**ADDENDUM No. 3**

Date September 02, 2014

Project Name Shoal Creek Greenbelt Trail Improvements

C.I.P. No. 6051.005

TRAIL PLAN AND PROFILE  
SHEET 1 OF 3

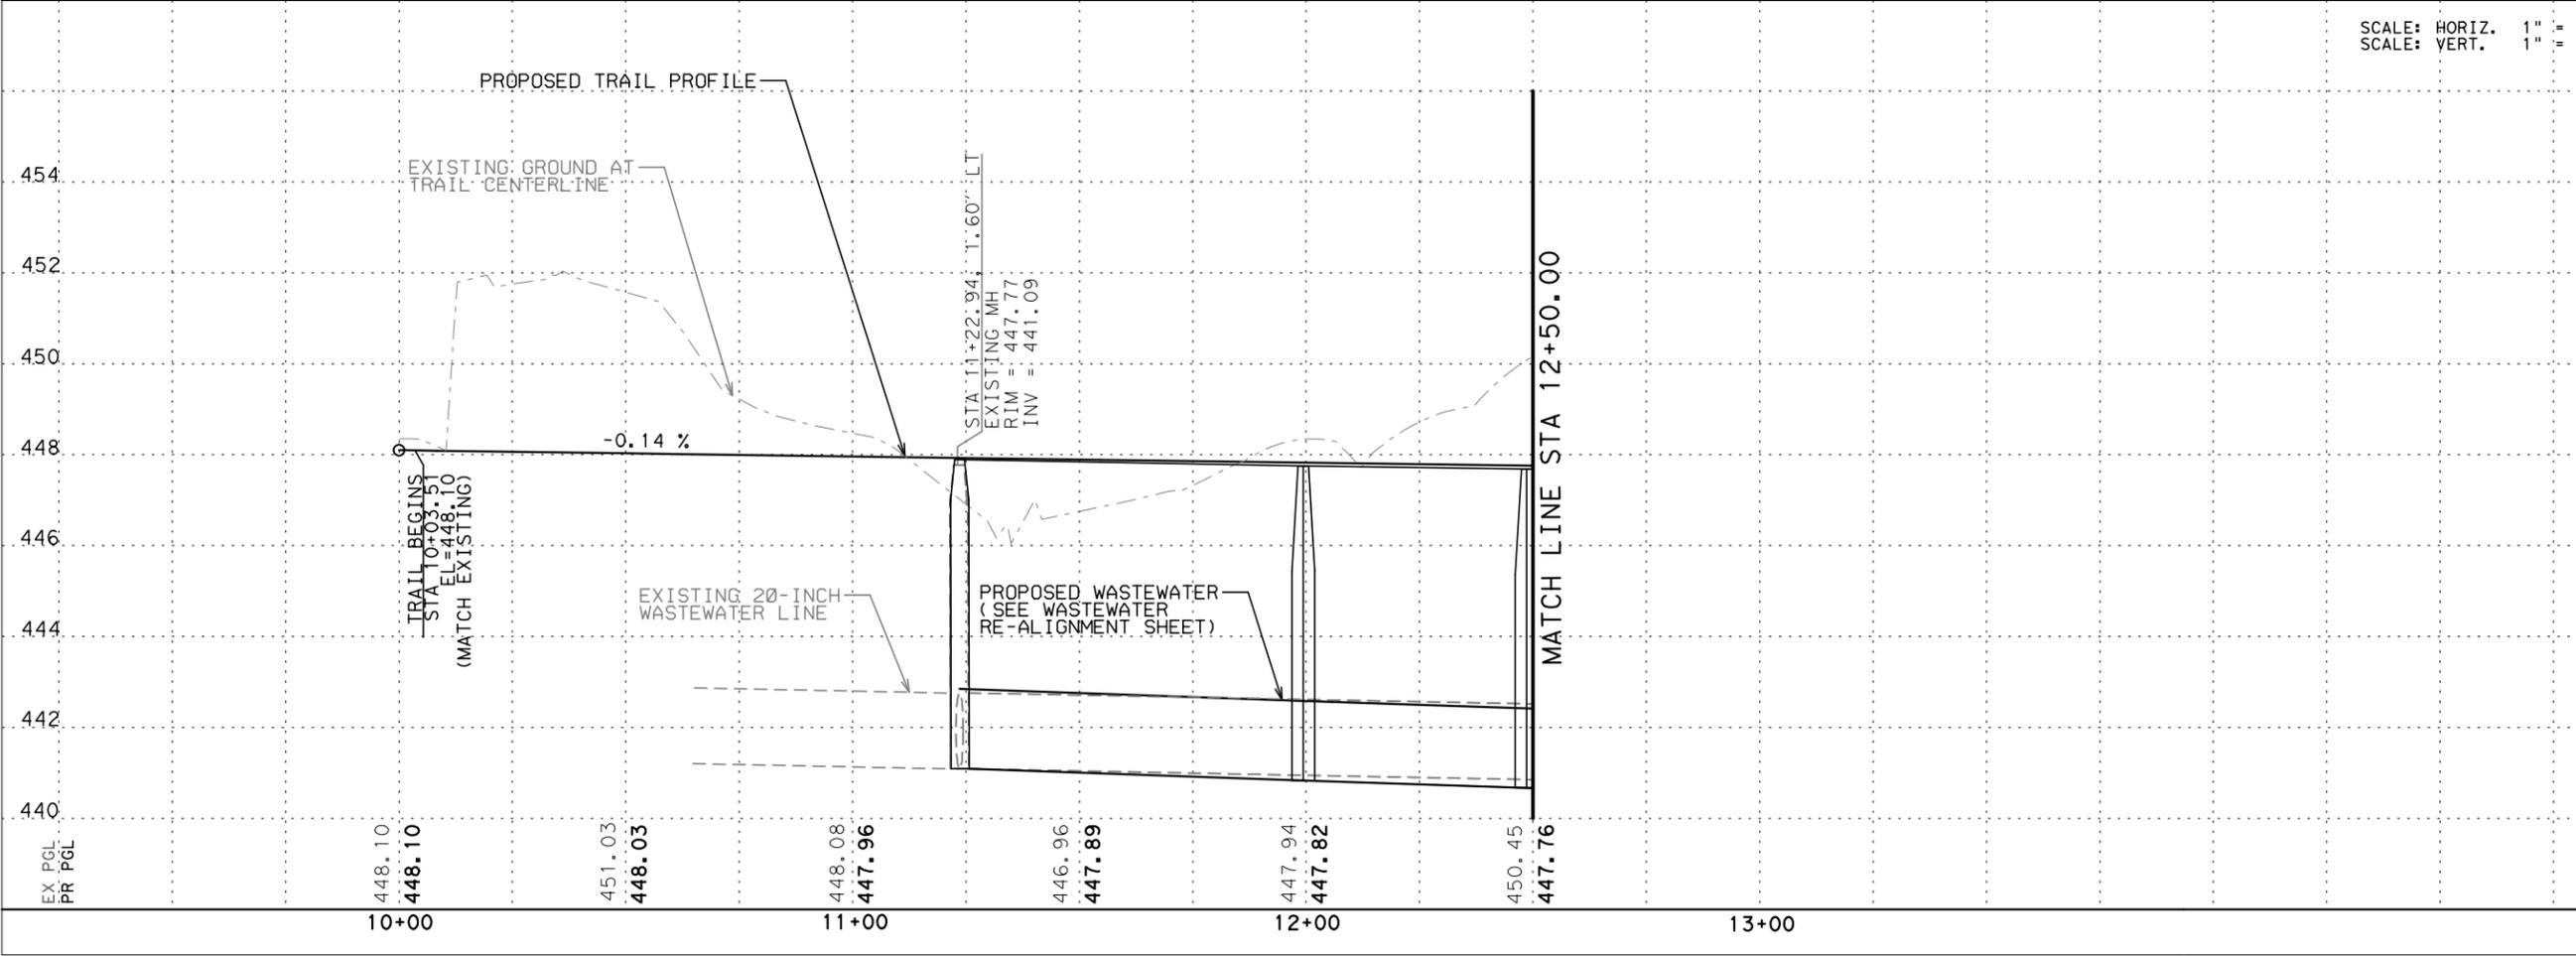
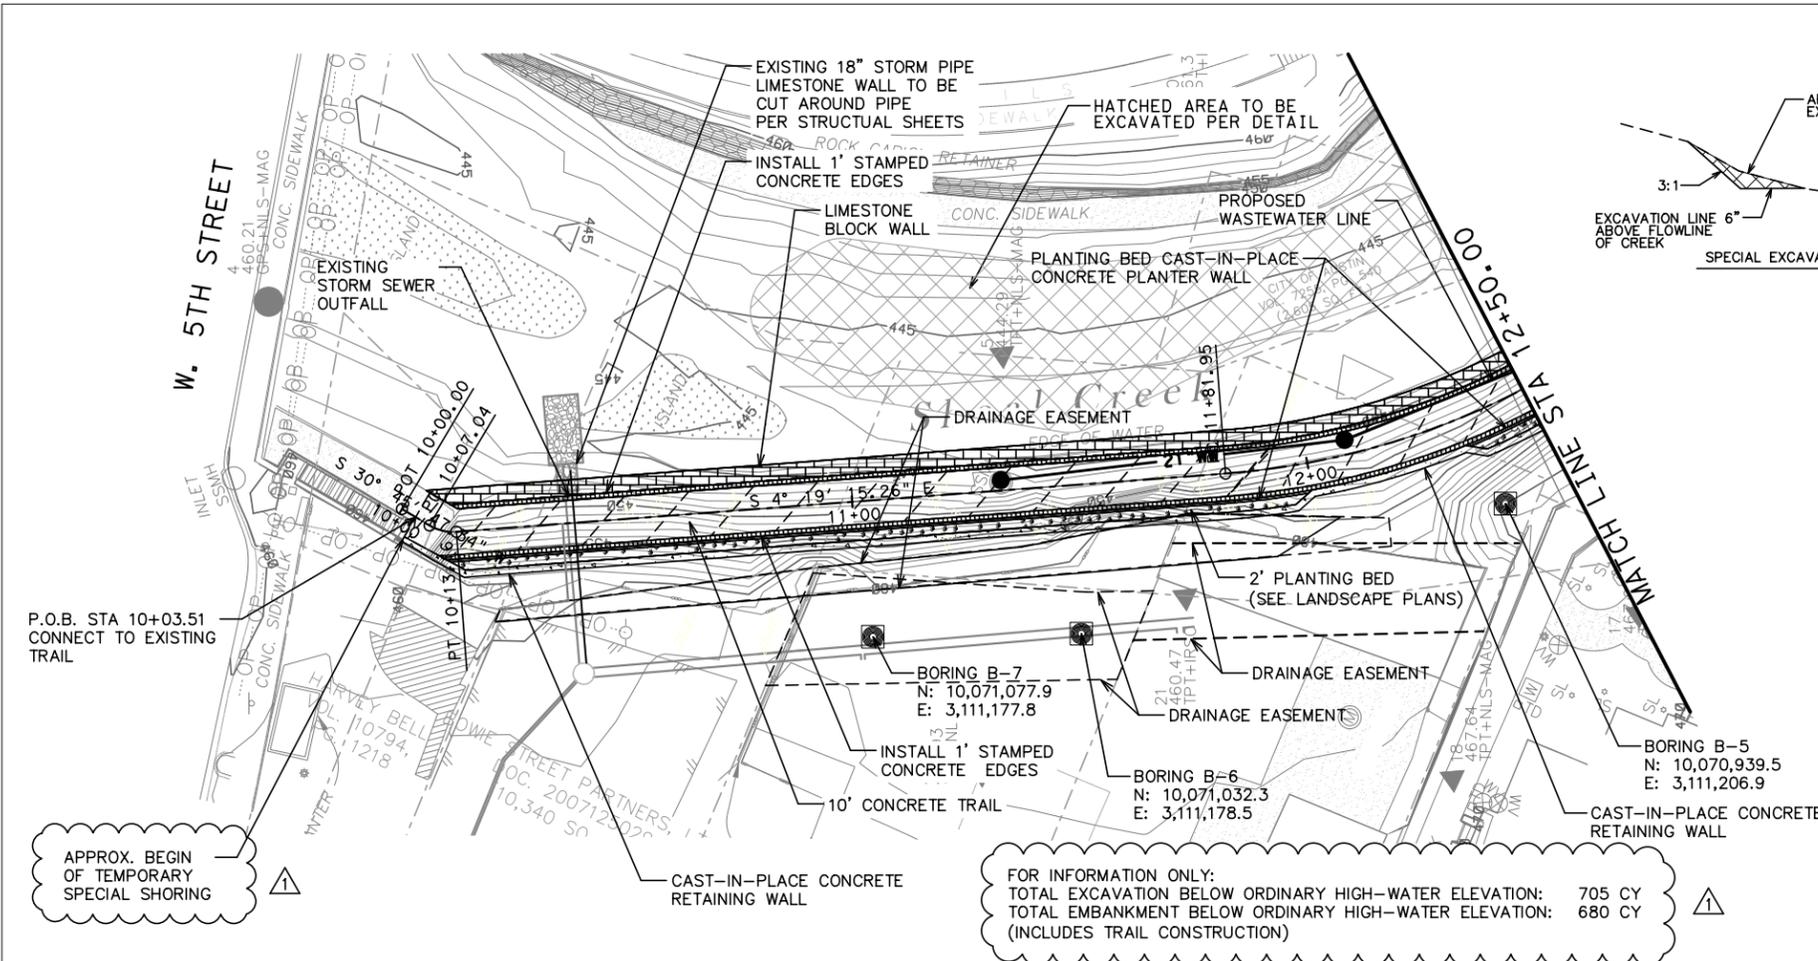
REV. NO.	DATE	DESCRIPTION
1	8/25/2014	ADD BARTHOLOMEOTT & TRIP, P&E, BOOKING

TRAIL PLAN AND PROFILE  
 SHEET 2 OF 3

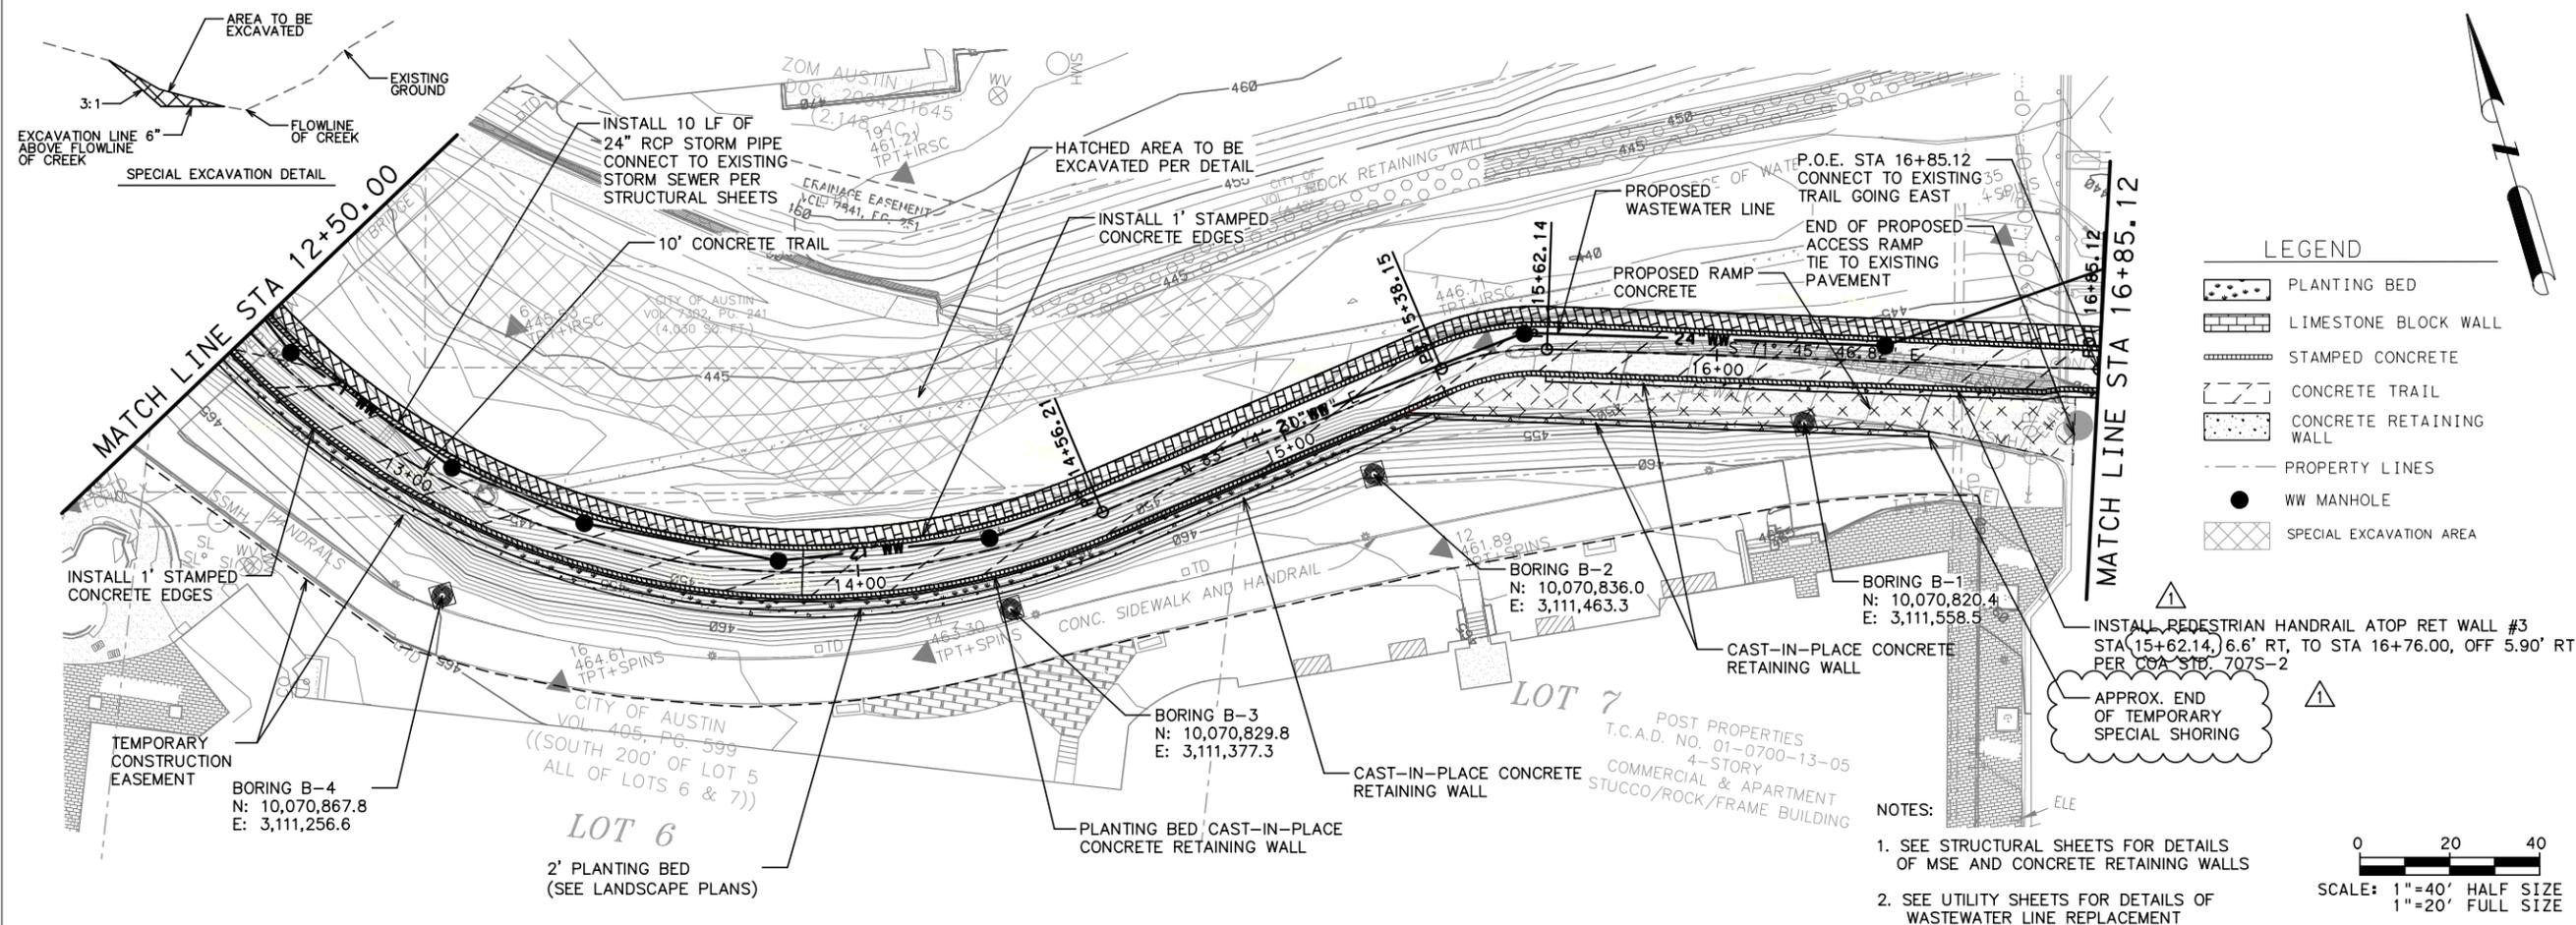
REV. NO.	DATE	REVISION DESCRIPTION
1	8/25/2014	ADD BARRIERS QTY & TEMP. SPECIAL BORING.

**MSE WALL REPLACEMENT PLAN  
EAST OF WEST AVENUE**

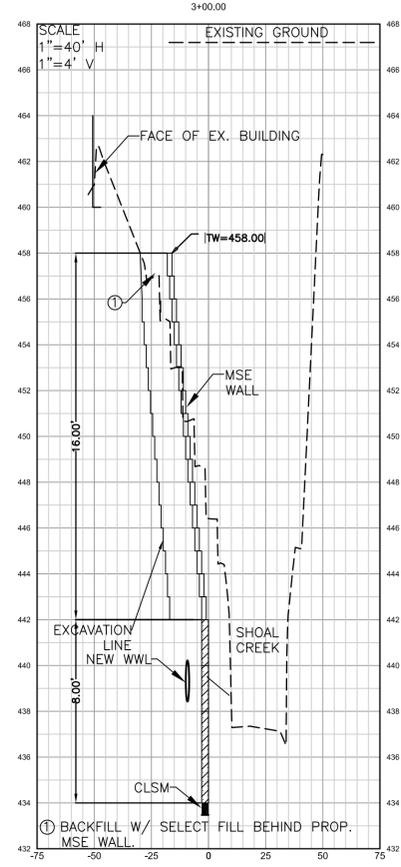
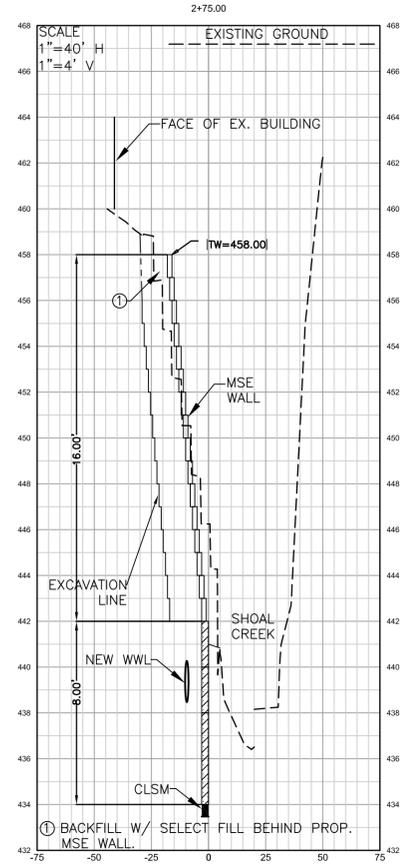
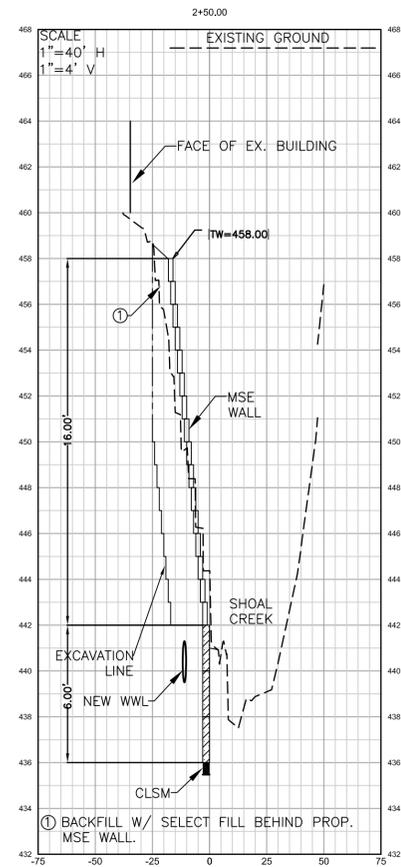
REV. NO.	BY	DATE	DESCRIPTION
1	CC	08/13/14	REMOVED CROSS SECTIONS

CAST-IN-PLACE RETAINING WALL 4  
 SHEET 1 OF 1

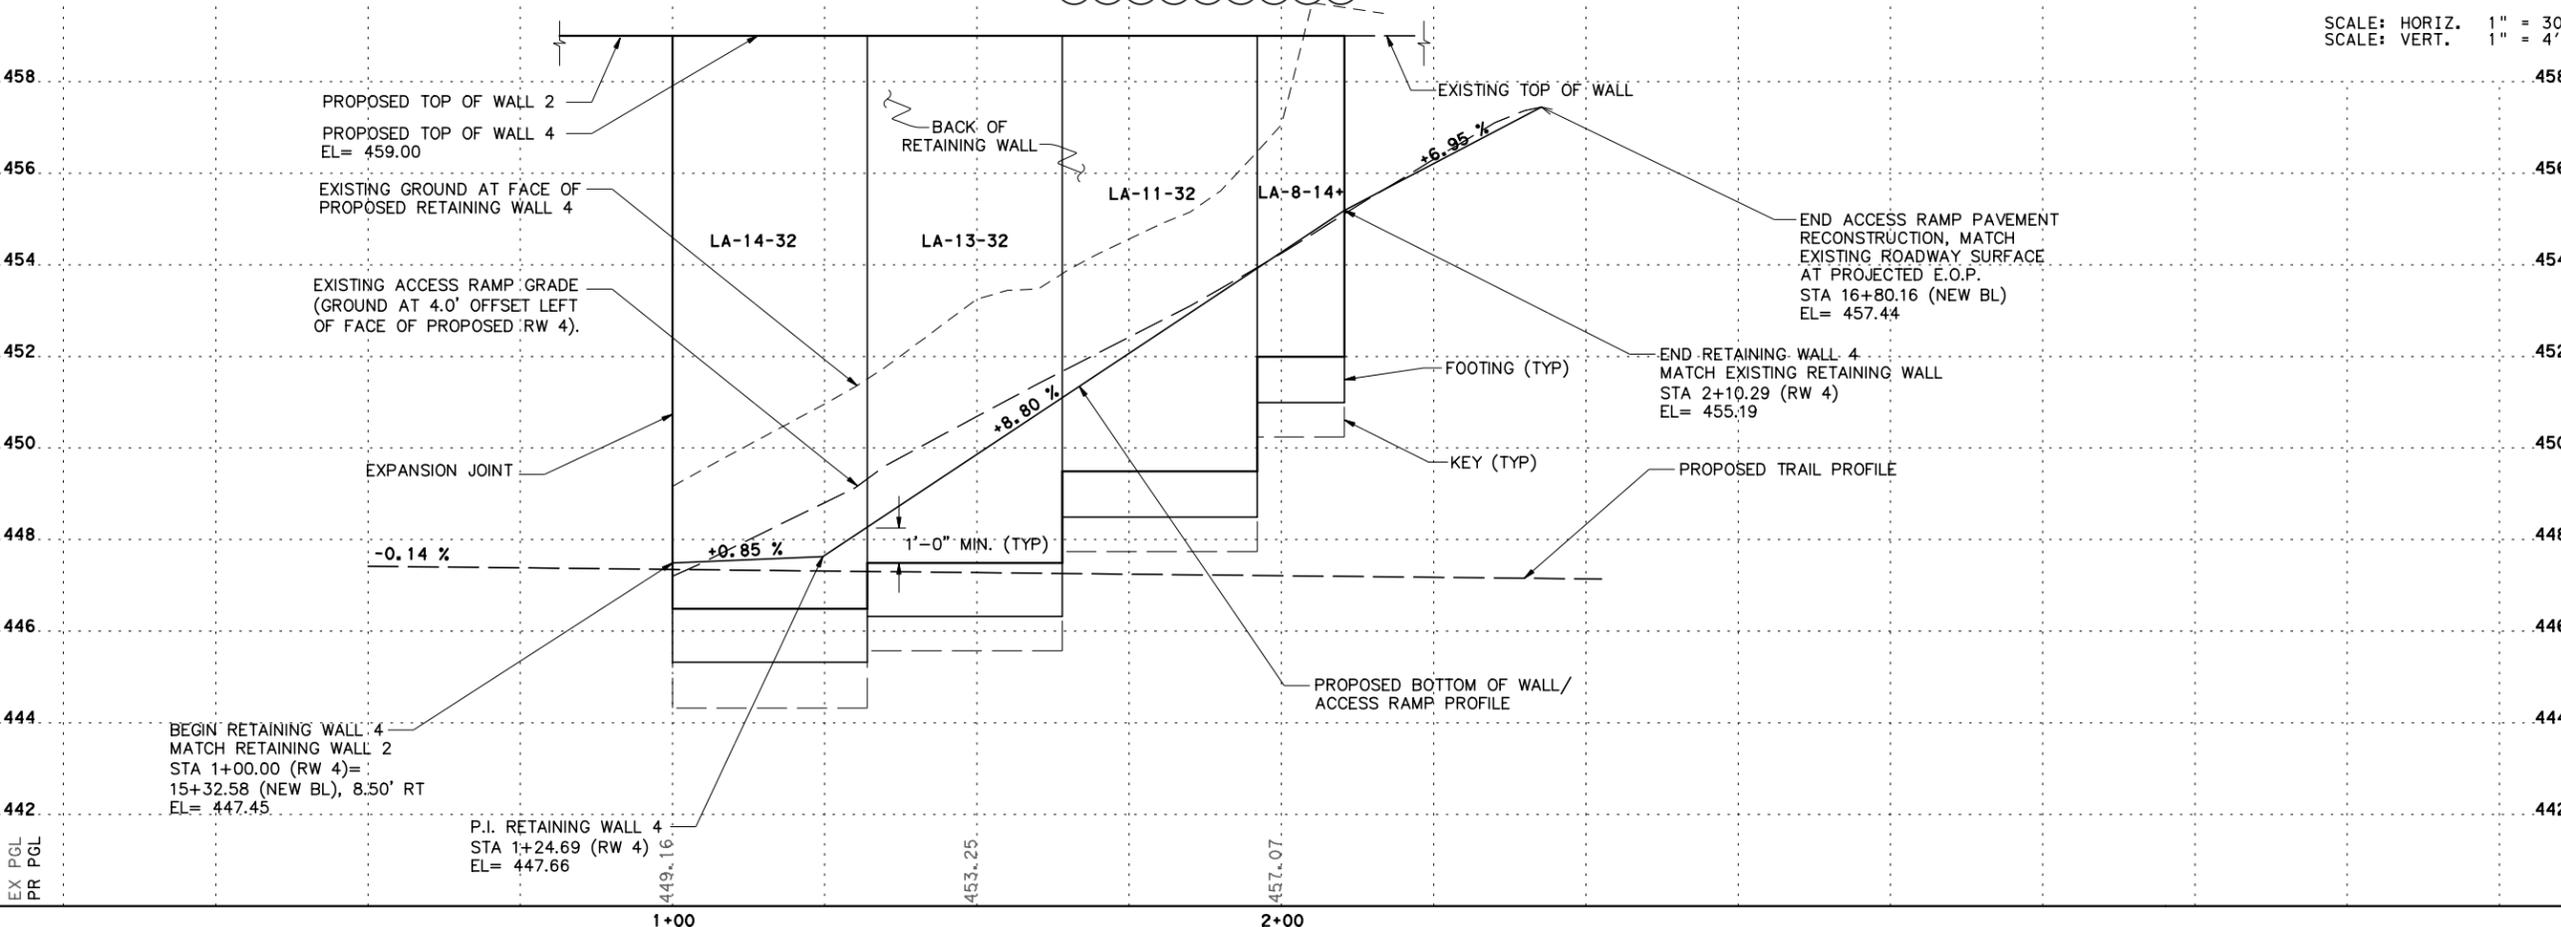
REVISION DESCRIPTION	DATE	REV. BY	NO.
ADD THERMAL BRIDGE	8/25/14	DD	1
